re: Geotechnical Review - McKinnon's Creek Alterations
Proposed residential Development
Summerside West - Tenth Line Road - Ottawa

to: David Schaeffer Engineering Limited - Ms. Jennifer Ailey - jailey@dsel.ca
to: David Schaeffer Engineering Limited - Mr. Steve Pichette - spichette@dsel.ca
to: Mattamy Homes - Ms. Jillian Normand - Jillian.Normand@mattamycorp.com
date: October 30, 2018
file: PG4049-MEMO.10 Revision 1

McKINNON'S CREEK
PROPOSED ALTERATIONS
PLAN AND CROSS-SECTIONS

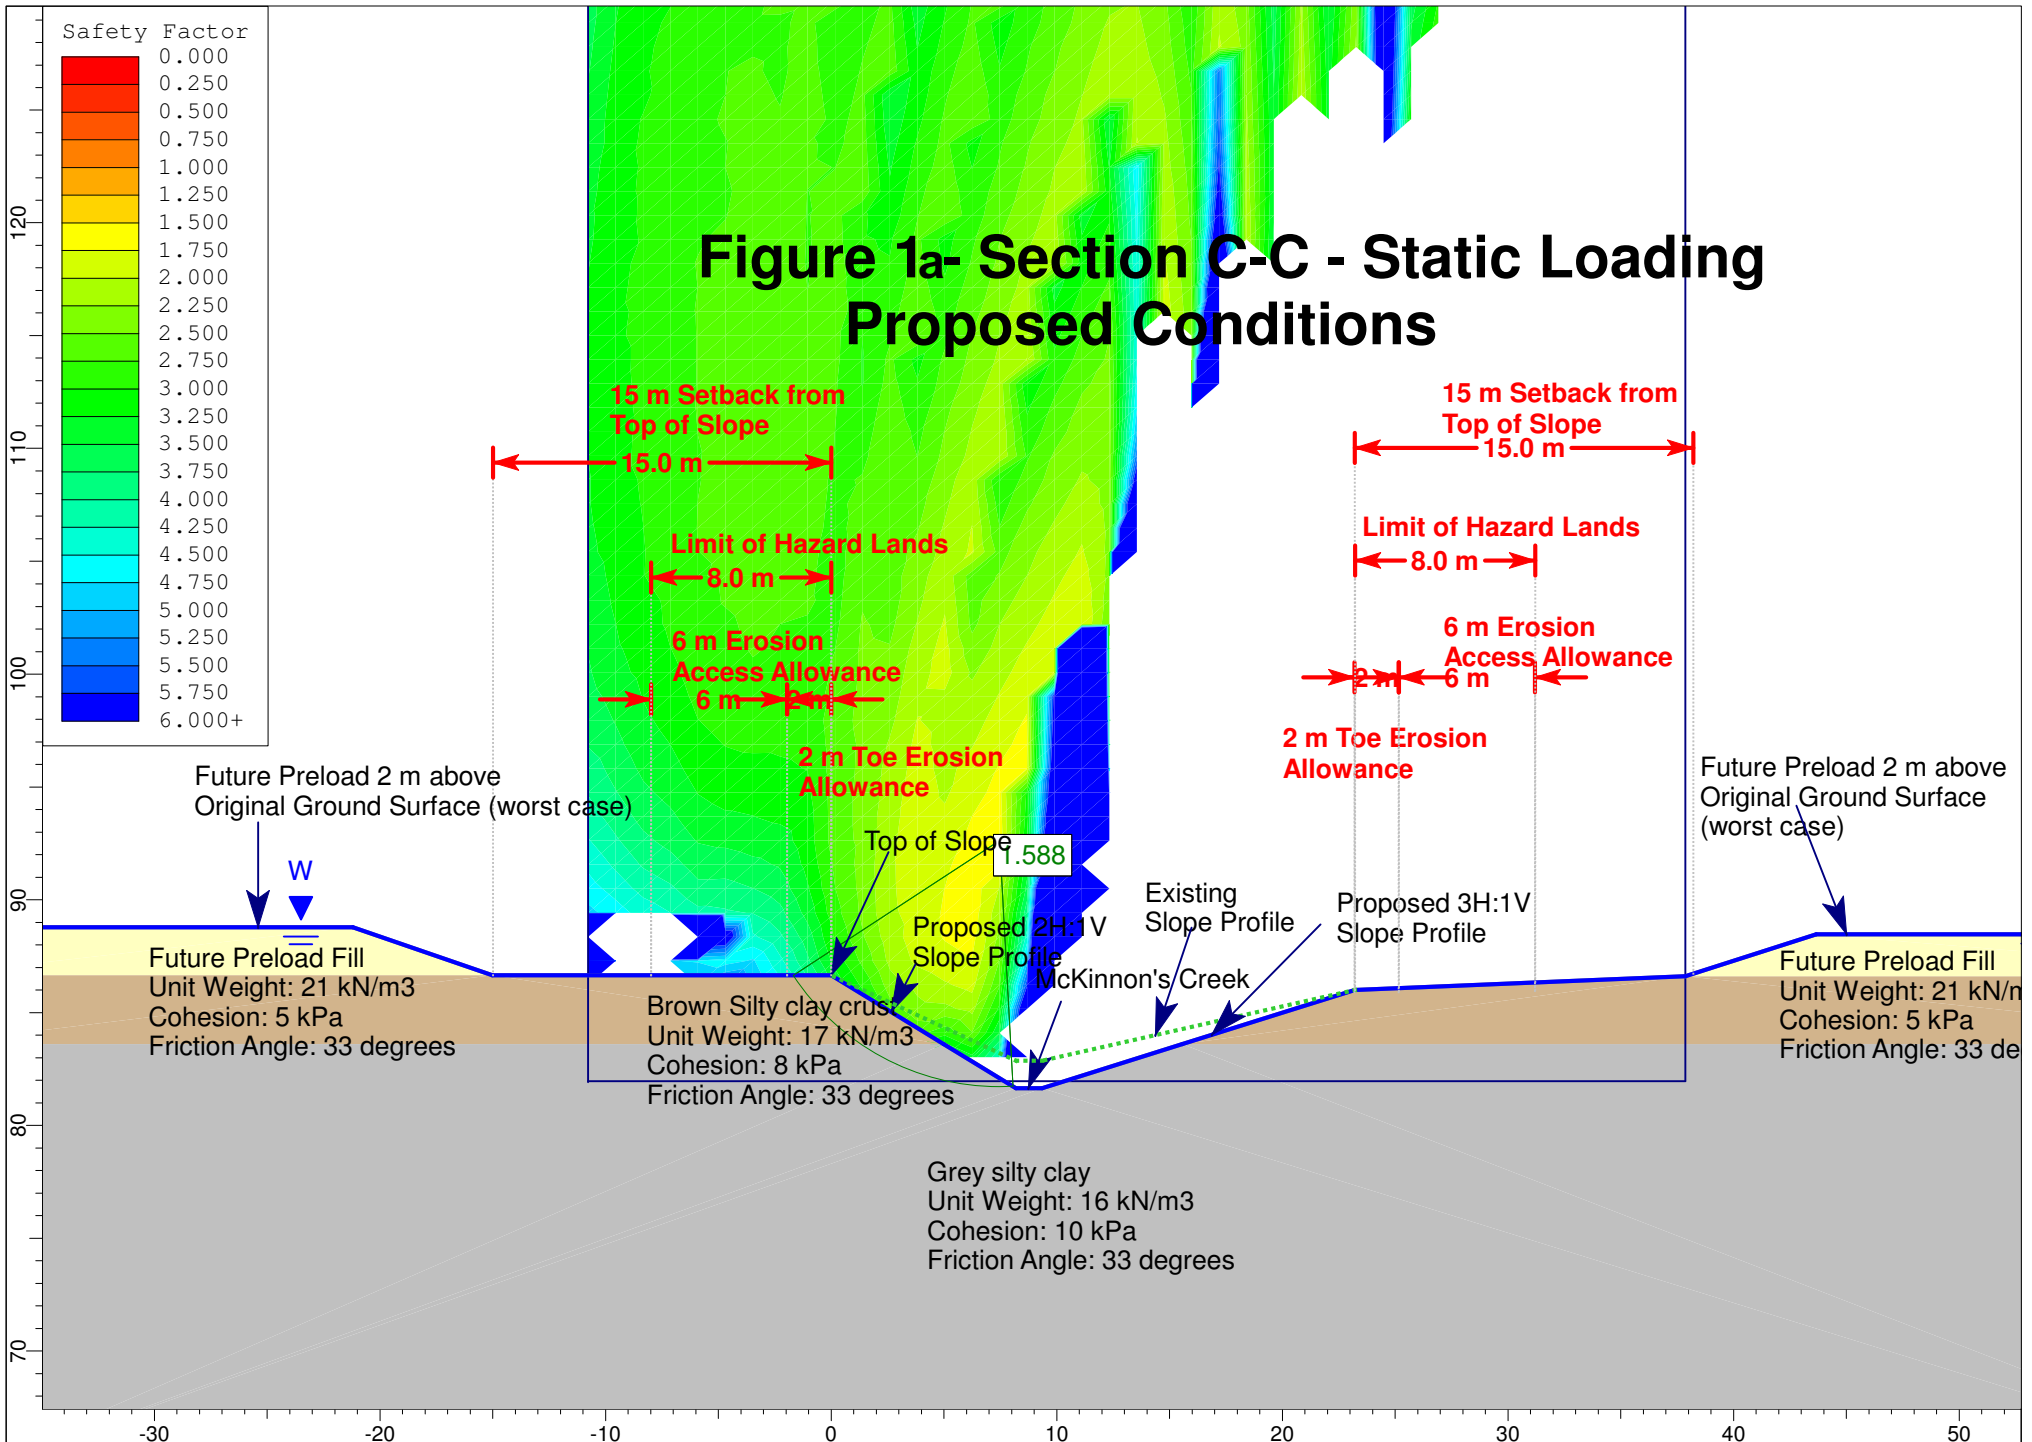
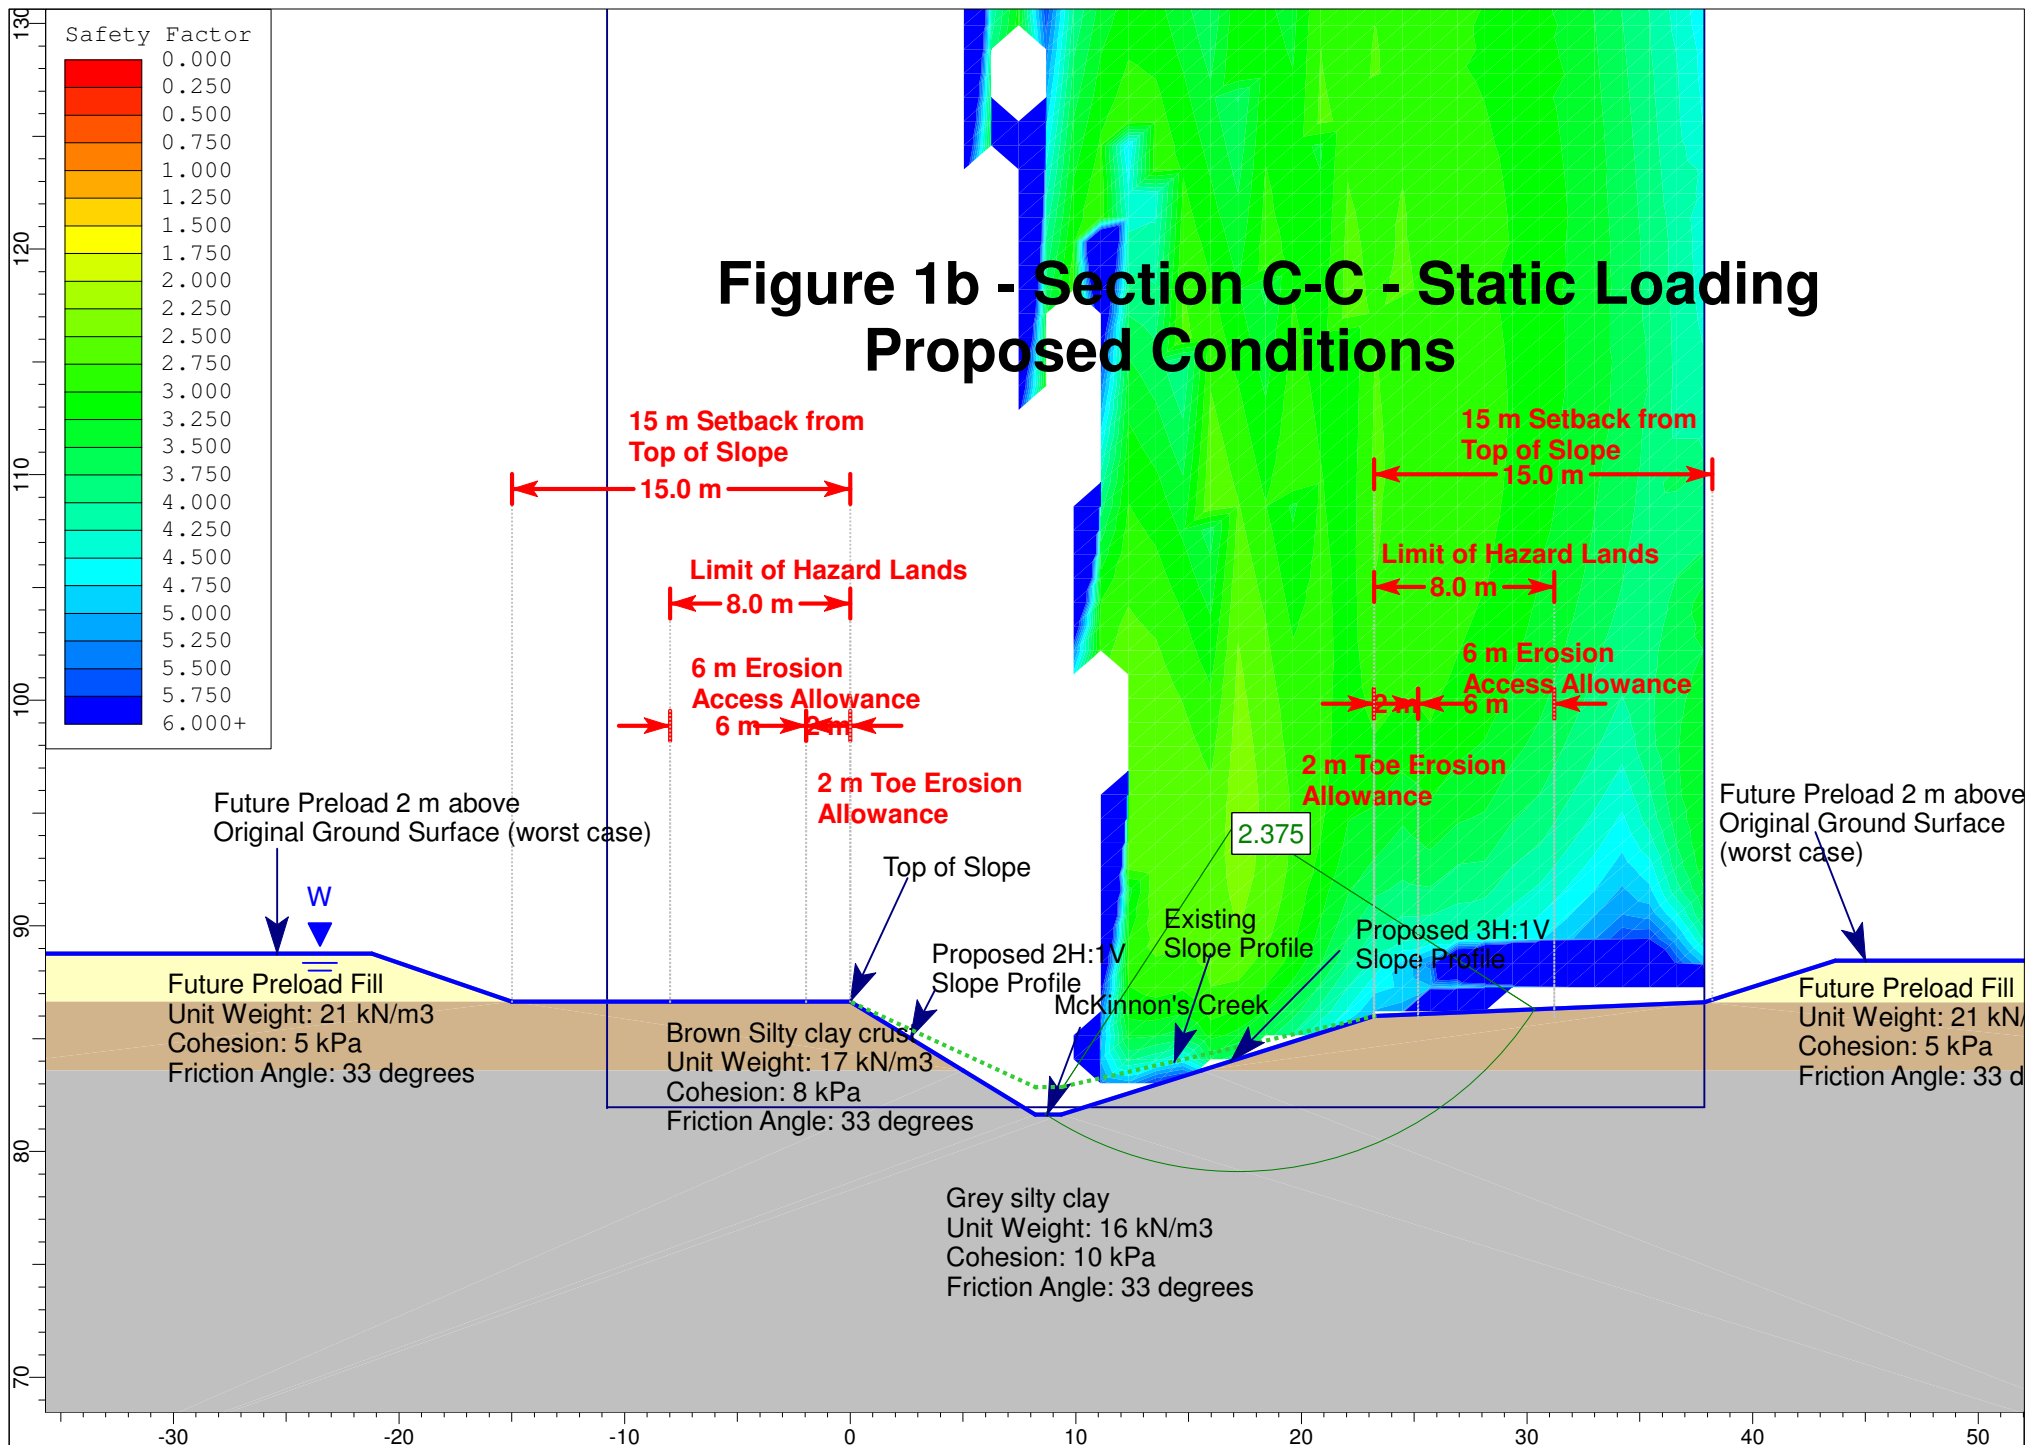
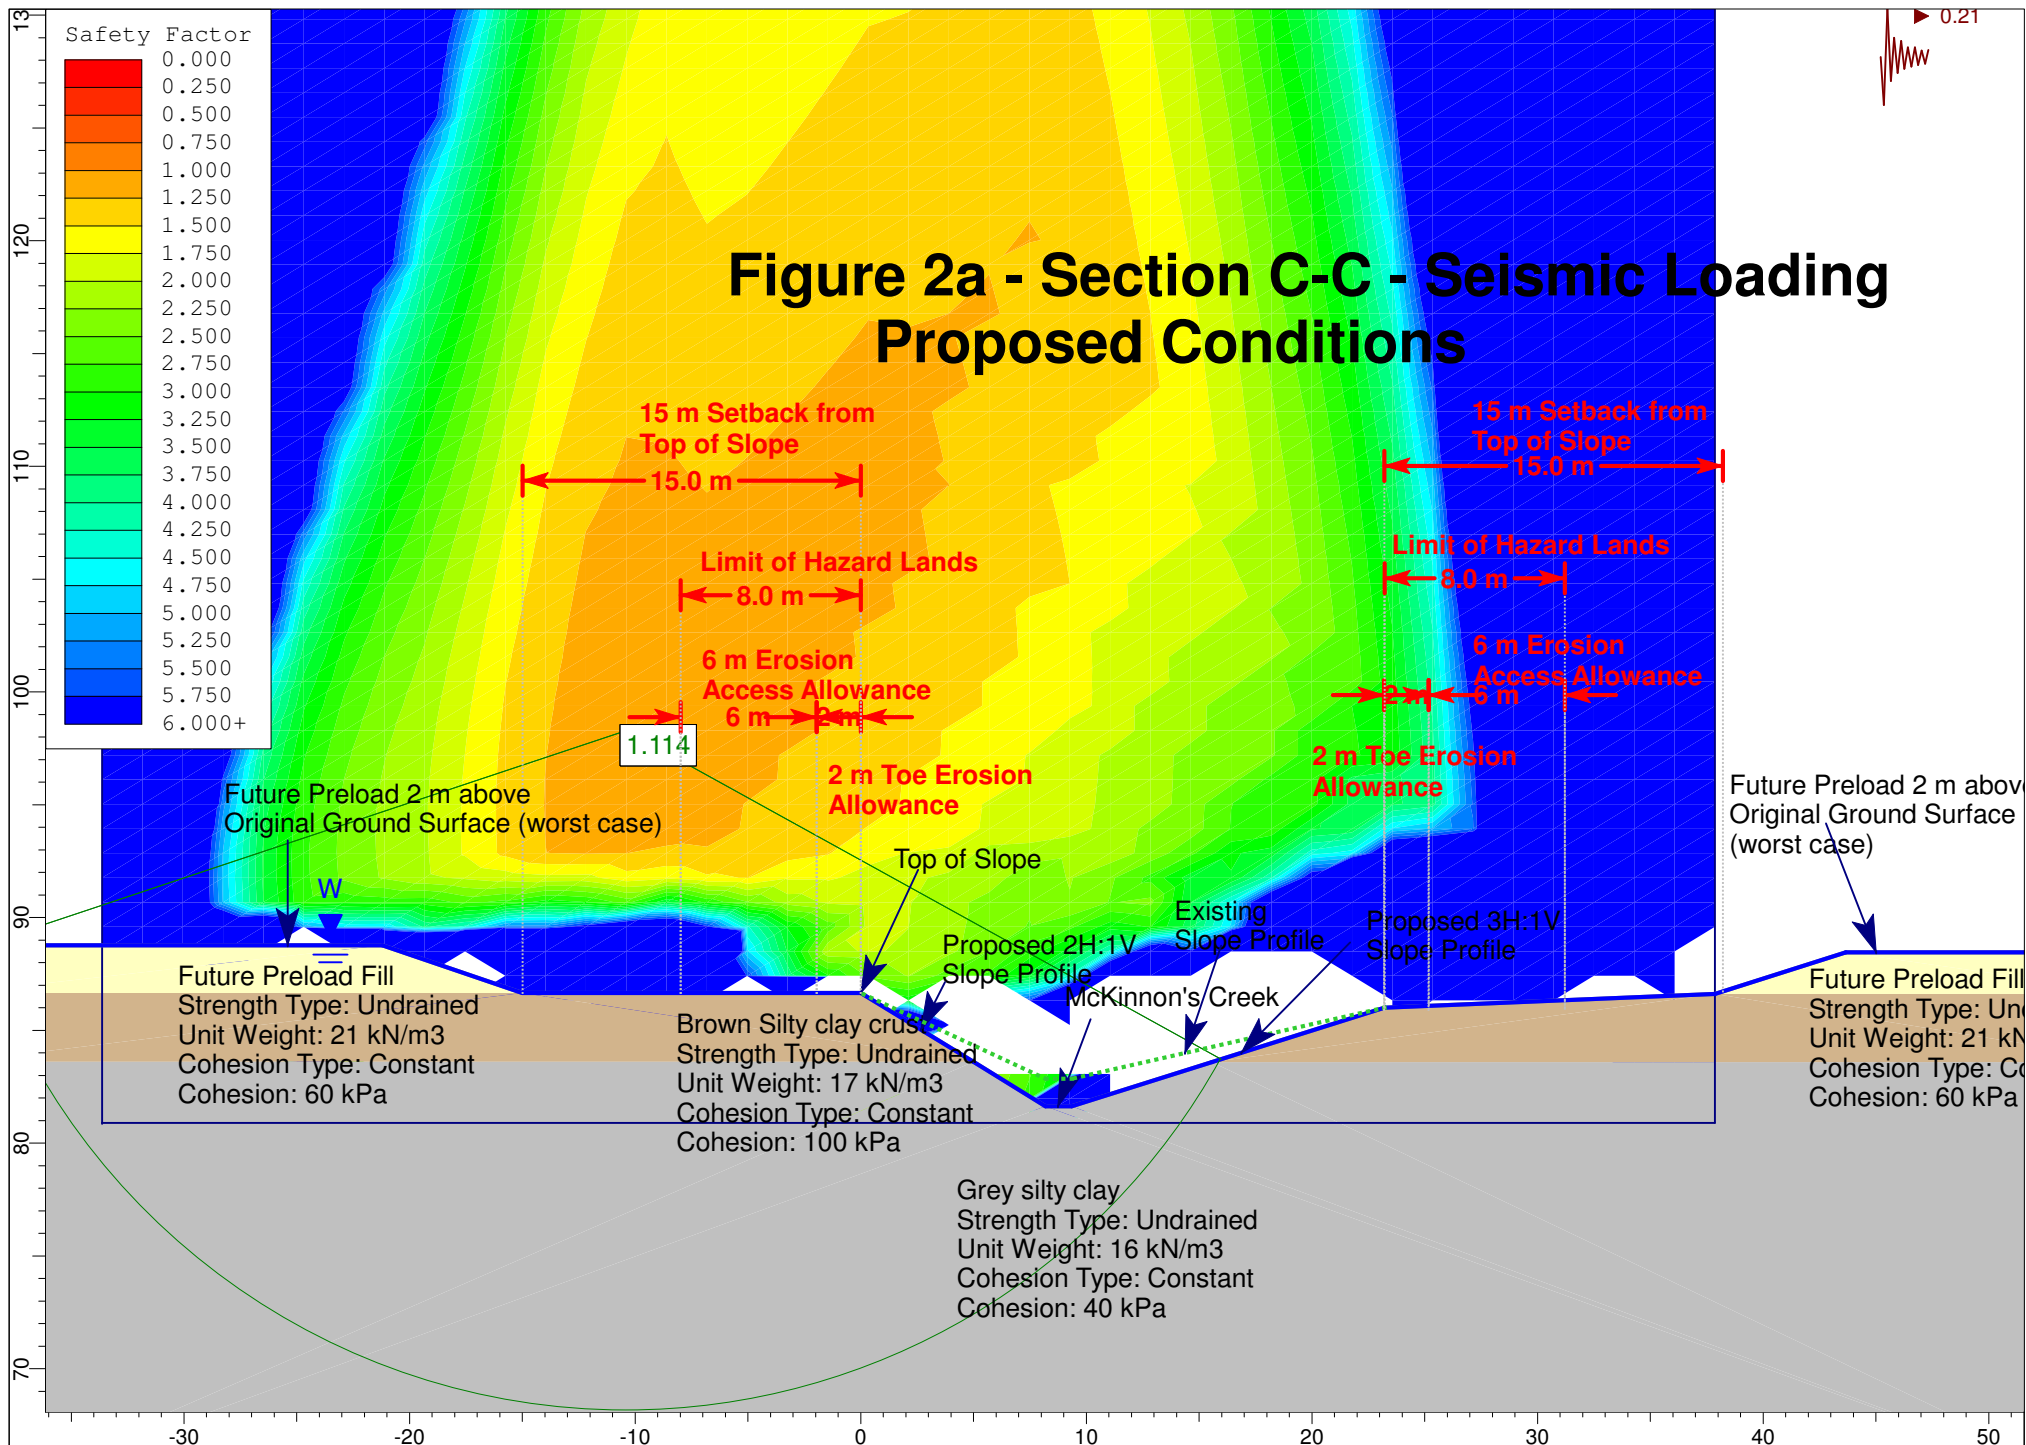
The results of our analysis are presented in Figures 1a, 1b, 2a and 2b attached. Figures 1a and 1b present the results of our global slope stability analysis under static conditions for each side slope of the channel and Figures 2a and 2b present the analysis when considering the seismic loading. Based on our analysis results, Section C-C is considered stable with a global slope stability factor of safety of greater than 1.5 under static conditions and greater than 1.1 under seismic loading. Therefore, a slope stability setback is not required for the limit of hazard lands setback.
